FLIGHT CONTROLS - AILERON POSITION TRANSDUCER CONNECTOR BRACKET RELOCATION

Relocation of the aileron position transducer connector bracket to avoid possible interference between the aileron trim cable and the aileron position transducer connector.

MTL-27-04
Page 1 of 5

Figure 1. Aileron Position Transducer Bracket Relocation (Sheet 1)

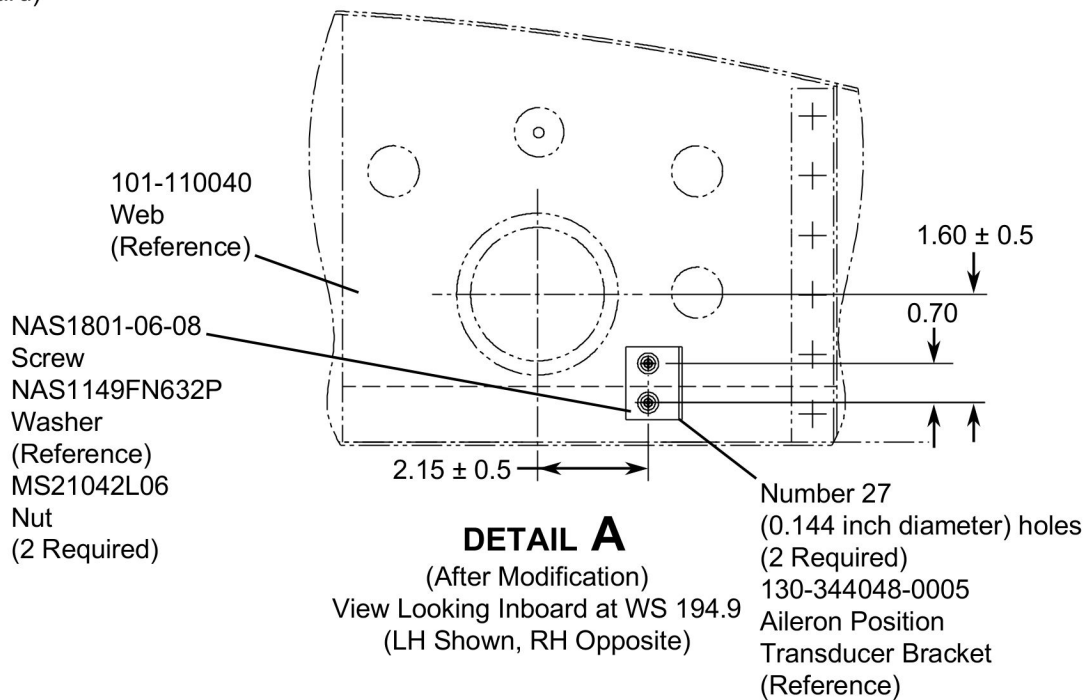
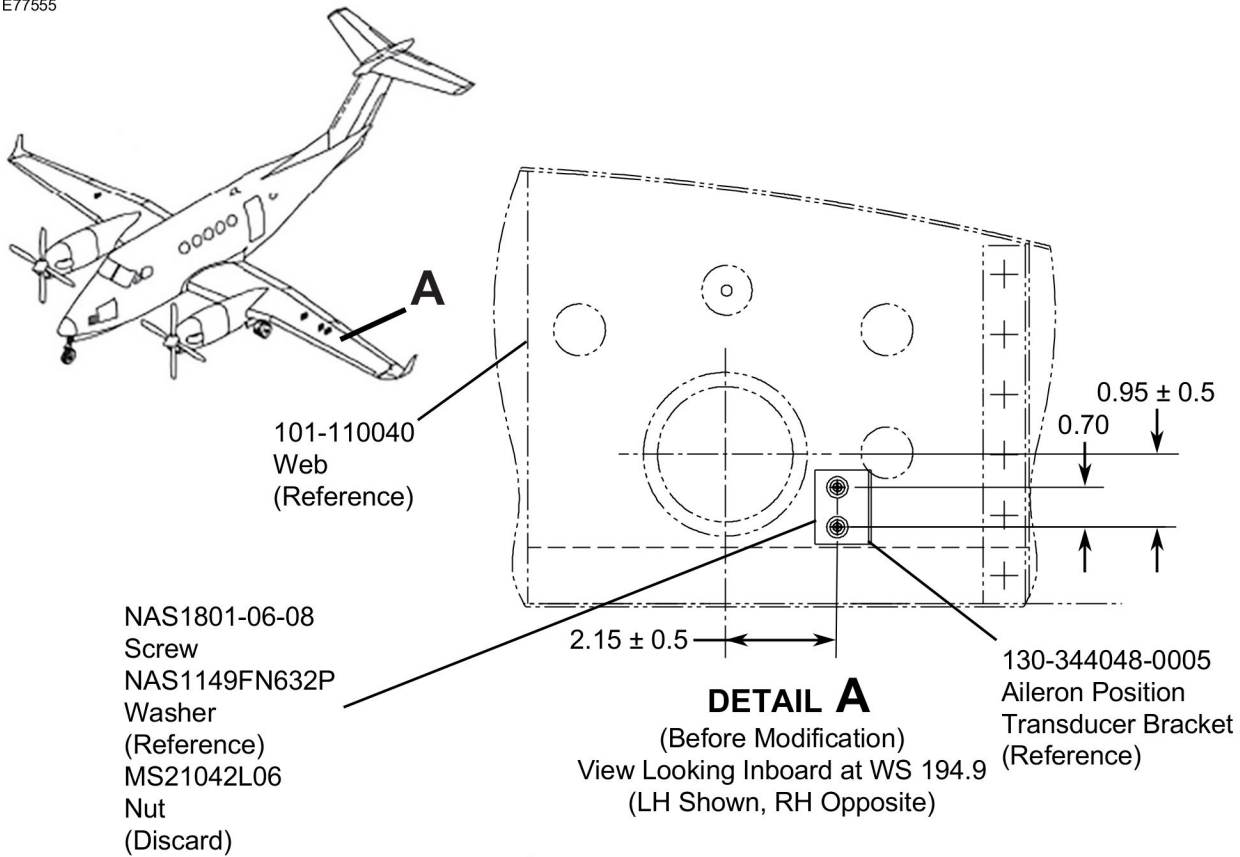
6. (Refer to Figure 1, Sheet 1.) Temporarily place the 130-344048-0005 Aileron Position Transducer Bracket onto the 101-110040 Web.
 - A. Connect the connector into the receptacle of the 130-344048-0005 Aileron Position Transducer Bracket.

8. (Refer to Figure 1, Sheet 1.) Mark and drill two Number 27 (0.144 inch diameter) holes in the 101-110040 Web to match the 130-344048-0005 Aileron Position Transducer Bracket.

9. (Refer to Figure 1, Sheet 1.) Install the retained 130-344048-0005 Aileron Position Transducer Bracket to the 101-110040 Web with the retained NAS1801-06-08 Screws and NAS1149FN632P Washers, and with the two new MS21042L06 Nuts.

- A. Debur the drilled holes.
- B. Apply U074093 (Alodine 1132) Color Chemical Film Treatment to the holes.
- C. Plug the existing holes. (Refer to the Beechcraft Structural Inspection and Repair Manual, Chapter 20, Minor Dents, Gouges, Scratches, Patches, and Minor Splice Repair.)
